# Access Compliance Report

### (Curb Ramps)

Intersection ID: 27288	Main Street: PIPER_STATION_DR	Cross Street: REA_RD	Location: SE
ADA ID: 793876AB07D3	Ramp Type: Perp	Initial Pass/Fail: Fail	Overall Compliance: No
Codes/Mitigation Info/Possible Solution		Field Measurements/Component Compliance	
Severity Score: 8.75

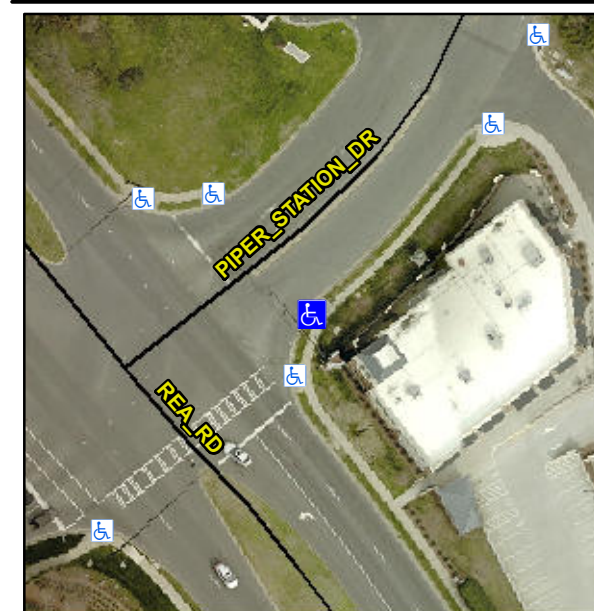
**Remove & Replace Entire Ramp.**

**Not Found, R304.5.1**
